Landscape Review Committee
Community Development Center, 231 NE 5th Street
March 18, 2020
12:00 PM

DATE: March 18, 2020
TO: Landscape Review Committee Members
FROM: Jamie Fleckenstein, Associate Planner
SUBJECT: Agenda Item 4B – Landscape Plan Revision Request (L 32-19)

A request to revise an approved landscape plan (L 32-19) and condition of approval to be reviewed by the Landscape Review Committee.

DECISION, CONDITIONS, FINDINGS OF FACT AND CONCLUSIONARY FINDINGS FOR THE APPROVAL OF A LANDSCAPE PLAN REVIEW AT 2019 NE HIGHWAY 99W

Figure 1: L 32-19 Approved Landscape Plan

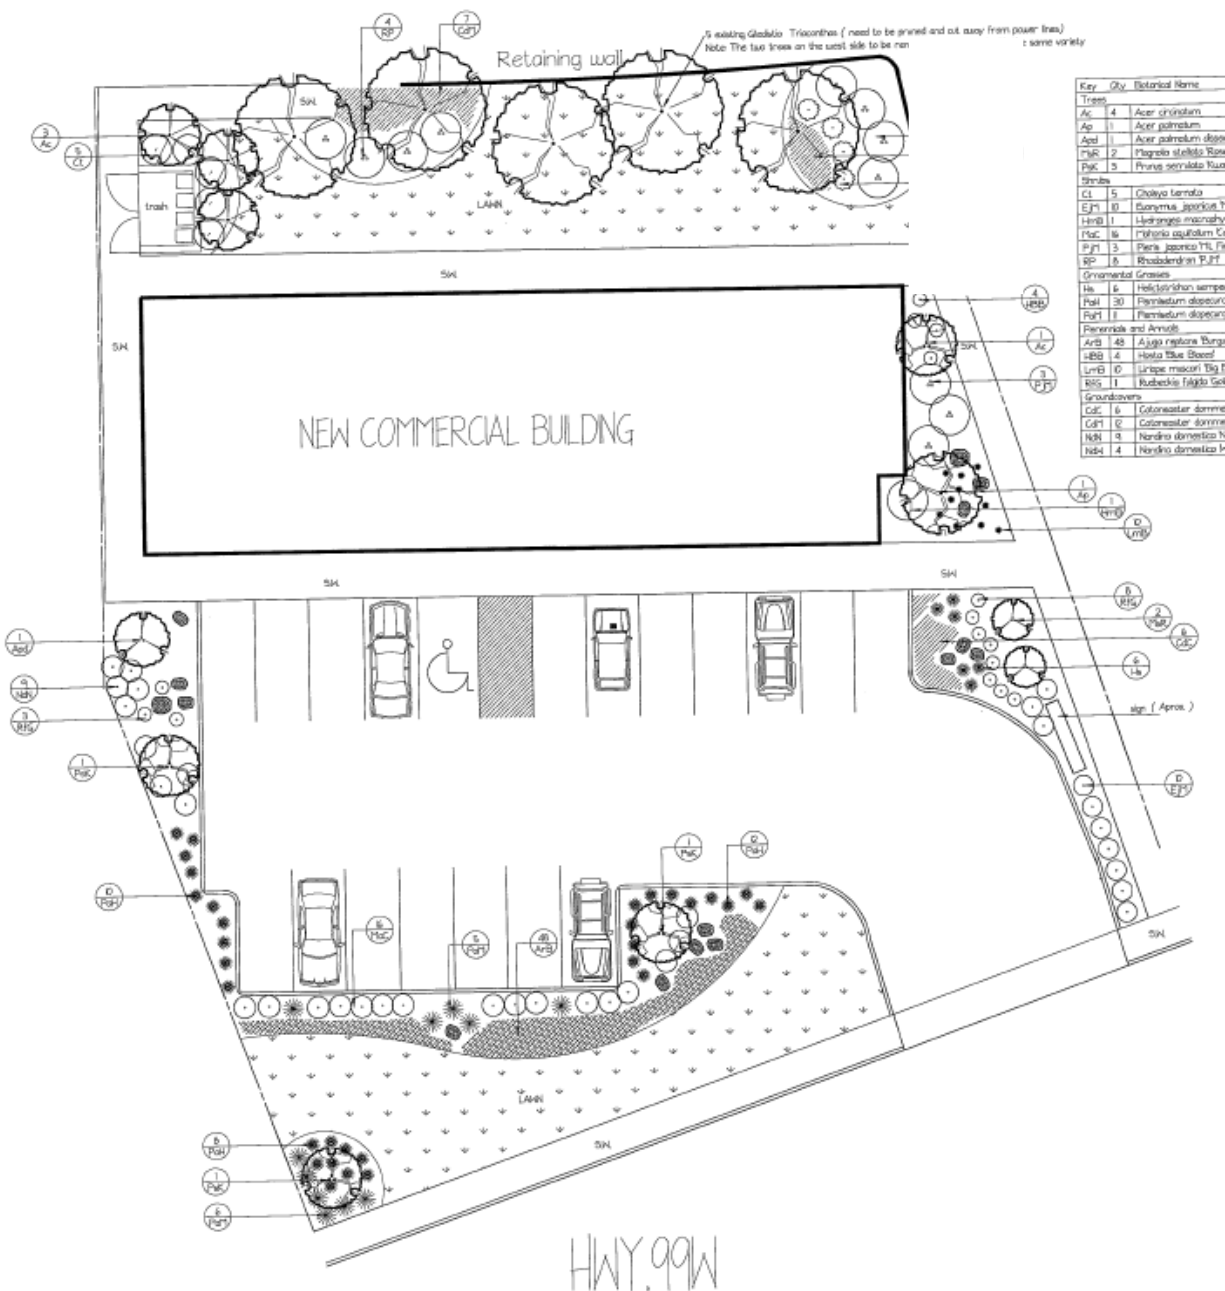
Following the Committee's approval of the Landscape Plan with conditions, it came to staff's attention that the dimensions of the parking spaces, and therefore the parking lot, as shown on the building permit submittal and landscape plan were smaller than required by code. Expansion of the parking lot was required to provide 8'-6" wide parking stalls instead of the 8'-0" wide parking stalls indicated on building plans. Because the parking lot would necessarily expand into the adjacent landscaping areas, inclusion of an internal parking lot island would likely require the loss of one parking stall. The site plan shows 18 parking stalls. Based on the size of the commercial structure, 17 parking stalls are required, though specific commercial tenants and uses are unknown at this time.

Out of a concern for preserving off-street parking for future commercial tenants, the applicant, Linda Cameron of Moore Architecture + Design, LLC, on behalf of Hanish and Jessie Basra, property owners, is proposing a revision to the landscape plan to increase the size of trees around the perimeter of the parking lot and removal of Condition of Approval #3 requiring an internal parking lot island.

The approved landscape plan provides planting around the perimeter of the parking lot, including two (2) *Prunus serrulata* 'Kwanzan' (Kwanzan Cherry) trees immediately adjacent to the parking lot. An additional Kwanzan Cherry tree is located south of the parking area in the southwest corner of the site near Highway 99W. **See Figure 3 (Parking Lot Landscaping).** Kwanzan Cherry trees grow to approximately 25 feet tall and 20 feet wide. The applicant is proposing to substitute a larger shade tree species that would provide more shade and benefit to the adjacent parking areas, thereby eliminating the need for an internal parking island.

Currently, the two (2) Kwanzan Cherry trees on the approved landscape plan provide some benefit to a limited portion of the parking area because of their relatively small height and spread. The third Kwanzan Cherry tree in the southwest corner of the property is not providing any benefit to the parking area because of the size and location of the tree.

Substitution of the Kwanzan Cherry for a larger tree species that grows taller and wider would provide substantially more benefit to the parking area. Benefits of a larger tree species would include increased shade that would help reduce the harmful effects of heat and glare associated with motor vehicle use, and increased canopy over the parking lot that would help reduce the rate of discharge of storm water runoff by capturing rain water before it can fall on impervious surface.

FINDING: SATISFIED. The proposed parking area for the commercial development is a single drive aisle with 12 parking stalls on the north side and 6 parking stalls on the south side. The north and south parking aisles have end caps with landscaping, and a large landscape area is adjacent to the southern parking aisle. Although the site plan for the proposed commercial development and off-street parking area does not provide internal landscape islands and planting therein, consideration was given to the landscape areas adjacent to the parking to provide planting that would provide benefit similar to or greater than an internal landscape island. The landscape plan indicates that three (3) shade trees are to be located south and west of the proposed parking area. Benefits of these shade trees around the parking area include increased shading that would help reduce the harmful effects of heat and glare associated with motor vehicle use, and increased canopy over the parking lot that would help reduce the rate of discharge of storm water runoff by capturing rain water before it can fall on impervious surface, achieving the purpose and intent of the Landscape chapter of the Zoning Ordinance.

1. That the applicant shall install landscaping as shown on the landscape plan submitted to the Planning Department on December 23, 2019, and as revised on March 18, 2020.
2. That if any of the five (5) existing *Gleditsia triacanthos* (Honeylocust) trees are removed, they shall be replaced with a tree species from the McMinnville Street Tree List – Recommended Small Tree Species approved for planting under overhead wires.
3. ~~That a parking lot island internal to the northern parking aisle and plantings therein shall be provided. Such landscaped islands shall have raised curbs, be a minimum five (5) feet in width, and shall contain at least one (1) deciduous tree.~~

Figure 5: Proposed Landscape Plan

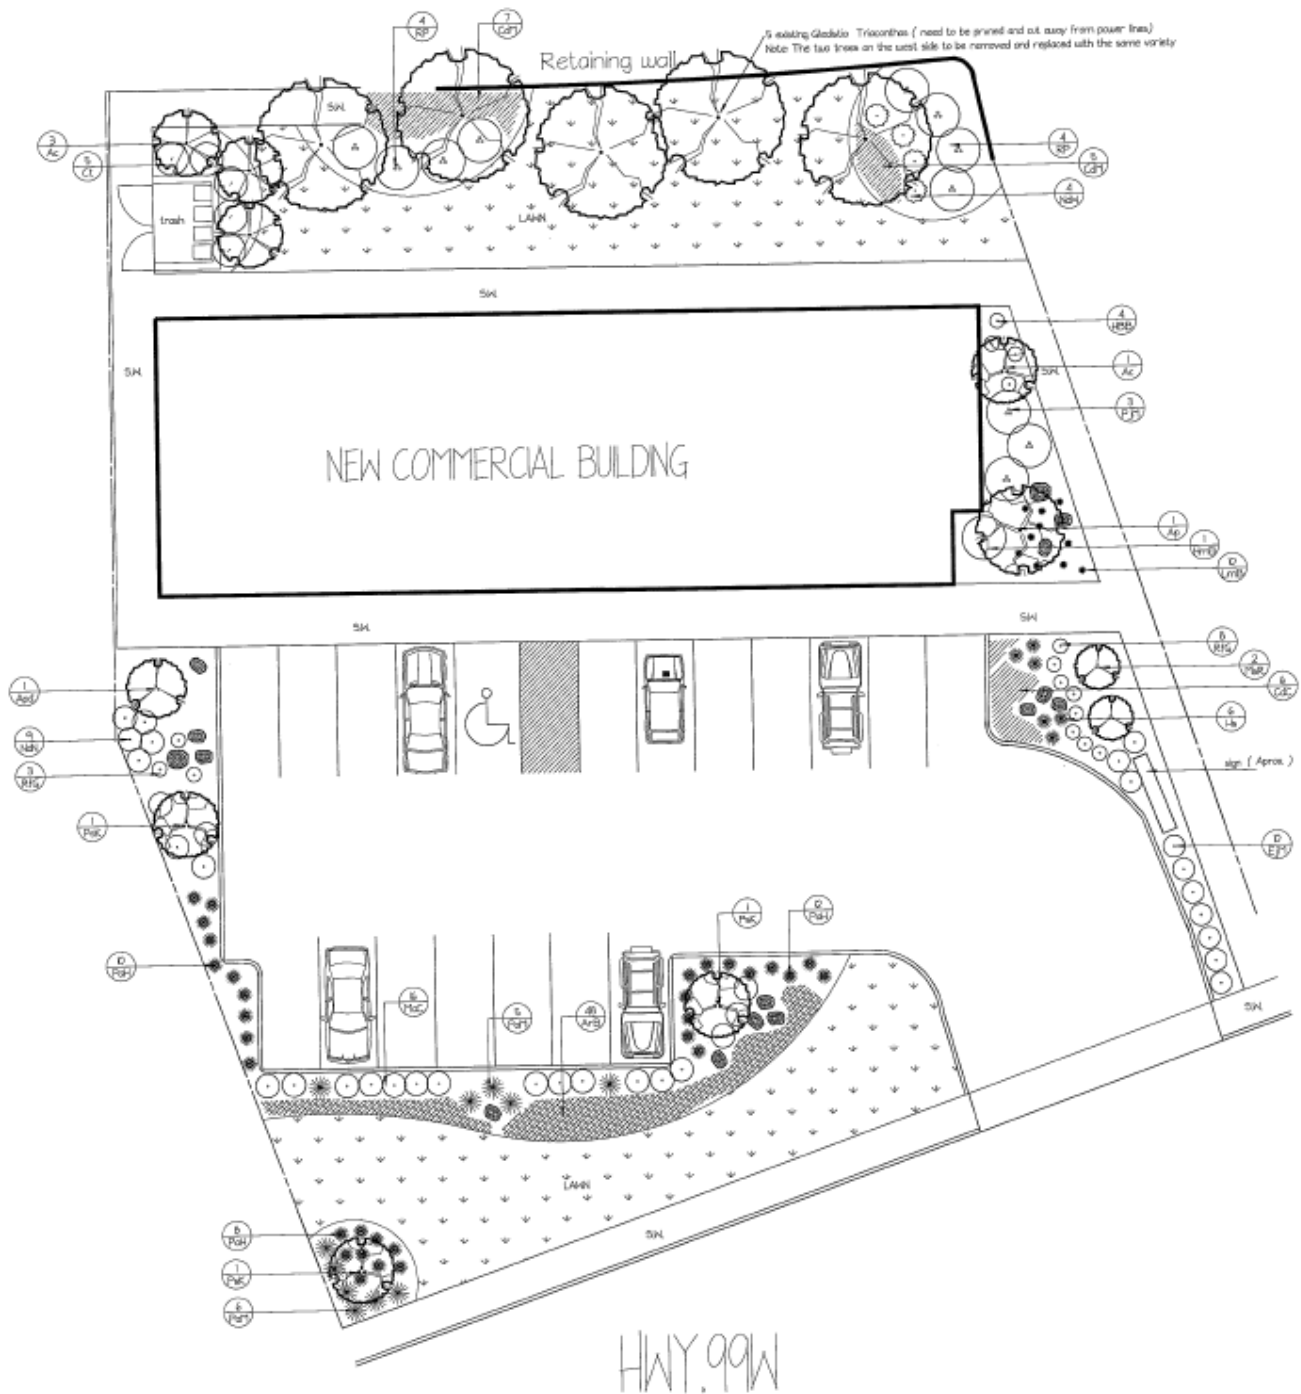
FINDING: SATISFIED WITH CONDITIONS #2. The proposed project is the development of a commercial shell building in the Highway 99W commercial corridor. Adjacent properties to the east, west, and south are commercially developed. Adjacent properties to the north are residentially developed. ***See Figure 7 (Vicinity Map Enlargement).***

The landscape plan indicates a centrally located commercial building on the site, with an off-street parking lot on the south side of the property, accessed from Highway 99W. The solid waste and recycling enclosure is located in the northwest corner of the site, accessed by a walkway that surrounds the new building and connects to the sidewalks in the adjacent rights-of-way.

1. That the applicant shall install landscaping as shown on the landscape plan submitted to the Planning Department on December 23, 2019, and as revised on March 18, 2020.
2. That if any of the five (5) existing *Gleditsia triacanthos* (Honeylocust) trees are removed, they shall be replaced with a tree species from the McMinnville Street Tree List – Recommended Small Tree Species approved for planting under overhead wires.
3. That landscaping be provided around a third side of the trash and recycling enclosure. Climbing vines and screening shrubs are appropriate, and plant material must be a minimum of three (3) feet in height at the time of planting.

Figure 10: Landscaping Along NE 27th Street

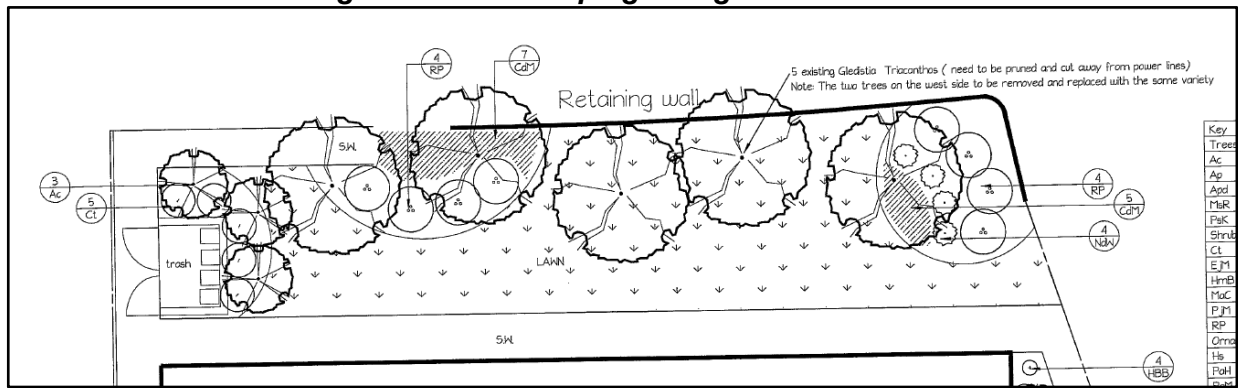
North of the commercial building, landscaping is proposed adjacent to NE 27th Street. There are five (5) existing deciduous *Gleditsia triacanthos* (Honeylocust) trees underneath power lines that run along the NE 27th Street right-of-way. The proposed trash enclosure is also located in this area. The three eastern Honeylocust trees are to be retained, and the landscape plan calls for replacing the two western Honeylocusts in-kind. Below the Honeylocusts, evergreen *Rhododendron* 'PJM' (PJM Rhododendron) and *Nandina domestica* 'Woods Red' (Woods Red Heavenly Bamboo) shrubs are proposed with evergreen groundcover. On two sides of the trash enclosure, evergreen *Choisya ternata* (Mexican Mock Orange) shrubs and *Acer circinatum* (Vine Maple) trees are proposed. The landscaping around the trash enclosure is addressed in more detail below. The remainder of the landscape area is a proposed turf lawn. The proposed planting will continue to provide and enhance the buffer between the commercially zoned subject site and the residential neighborhood to the north.

Honeylocust trees can grow to 30 to 70 feet tall depending on the specific variety. The variety of the existing trees is unknown. Honeylocust are generally not planted under power lines because of their mature height and growth characteristics. Continued maintenance would be required to keep the trees clear of the overhead utilities, and such maintenance is noted on the landscape plan. Because of this, replacement trees appropriate for planting under overhead utility lines is recommended to make the landscaping compatible with the utilities. A condition of approval is included to require that any of the existing *Gleditsia triacanthos* (Honeylocust) trees that are removed be replaced with a tree species from the McMinnville Street Tree List – Recommended Small Tree Species that is approved for planting under overhead wires.

CONDITION FOR FINDING: That if any of the five (5) existing *Gleditsia triacanthos* (Honeylocust) trees under the overhead utilities are removed, they shall be replaced with a tree species from the McMinnville Street Tree List – Recommended Small Tree Species approved for planting under overhead wires.

Applicant's Attachment B: Landscape Plan Revision

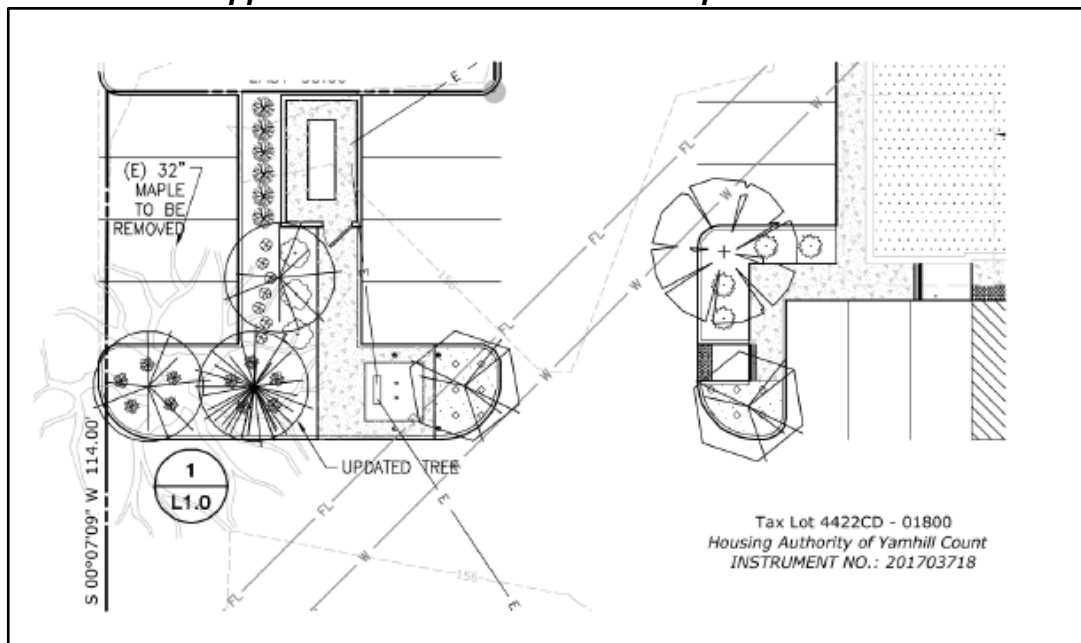
APPLICANT'S RESPONSE: The Applicant would like to preserve the mature tree in the west parking area as illustrated in Attachment B. The submitted narrative stated there were not any trees to be retained in development. The revision to the landscaping plan and legend shows that one Columnar Blue Atlas Cedar will be preserved.

FINDING: SATISFIED. A revision to the landscape plan shows that one Columnar Blue Atlas Cedar tree will be preserved on site. A 32 inch diameter maple tree is present on the site, but does not appear to be feasible to retain given the location of the tree and the location of new parking areas and utility structures in immediate area.

Applicant's Attachment B: Landscape Plan Revision

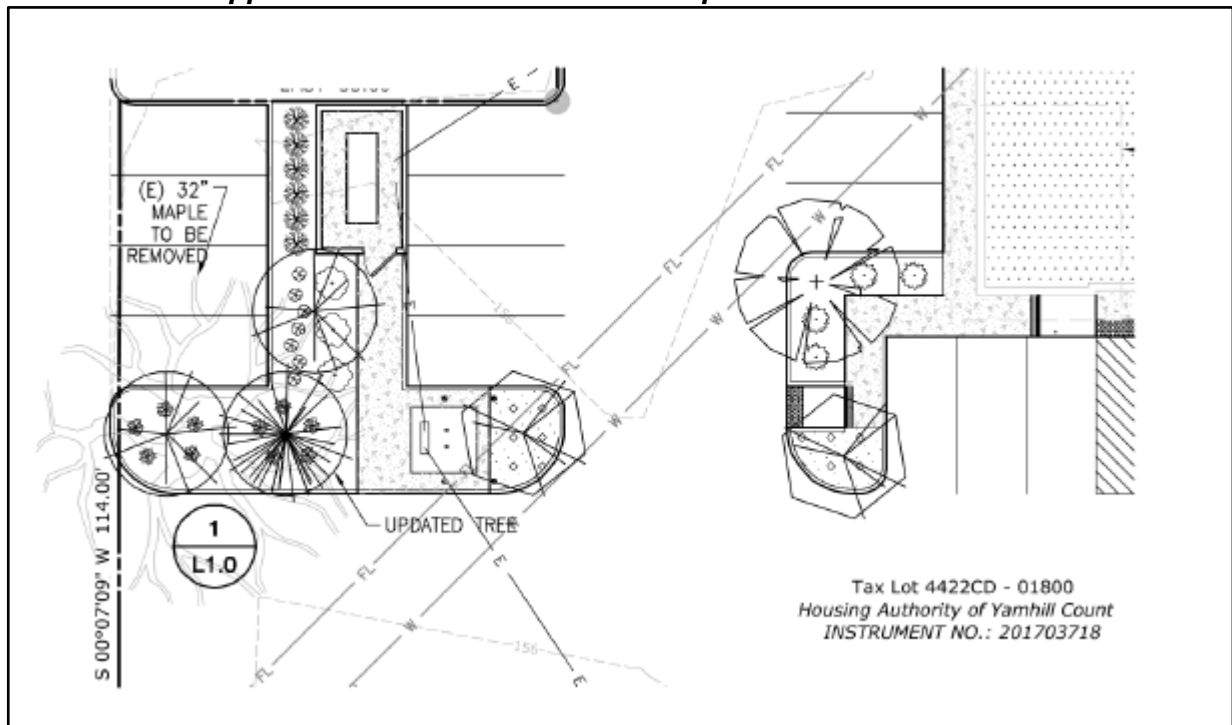
FINDING: SATISFIED. The City concurs with the applicant's finding's finding. The Landscape Plan indicates that one (1) large exiting tree is proposed for removal. The applicant has indicated the location, type, and size of the trees requested for removal on the Landscape Plan, shown in more detail in the Applicant's Attachment B shown below. The requested tree removals are not designated as exempt by the zoning ordinance, therefore the requested removals require City approval.

CONDITION FOR FINDING: That the 32 inch maple tree identified on Landscape Plan L1.0 Street Tree Plan shall be approved for removal.

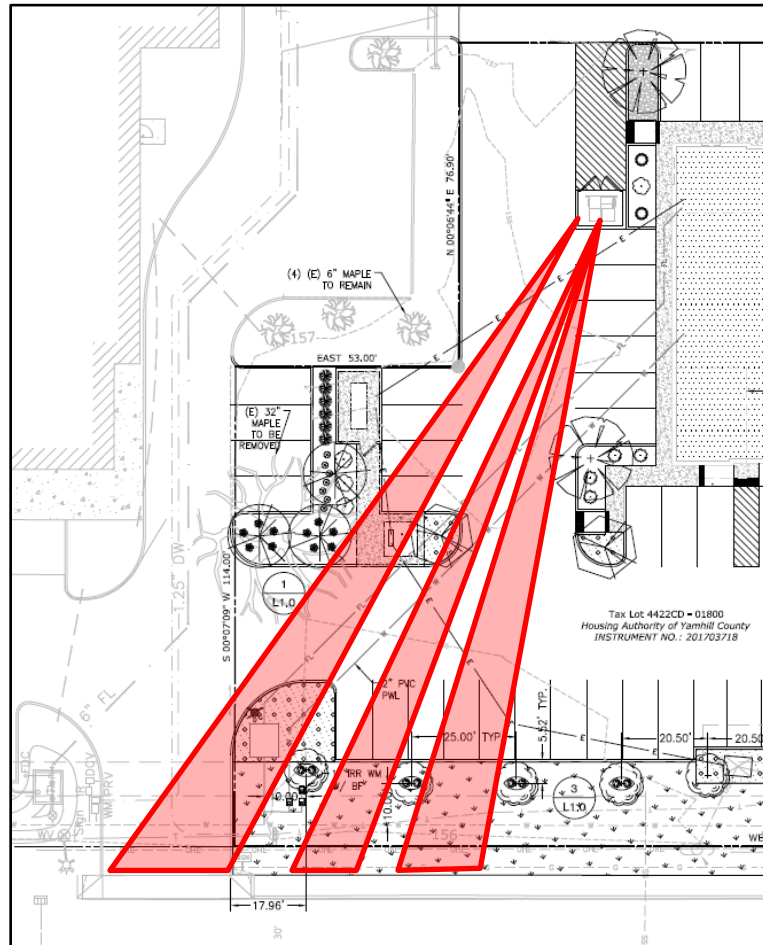
parking lot would partially obscure the enclosure, but sight-lines from the public right-of-way to the enclosure exist.

Therefore, a condition of approval is included to require landscaping be provided around three (3) sides of the trash and recycling enclosure. Climbing vines and screening shrubs are appropriate, and plant material must be a minimum of three (3) feet in height at the time of planting.
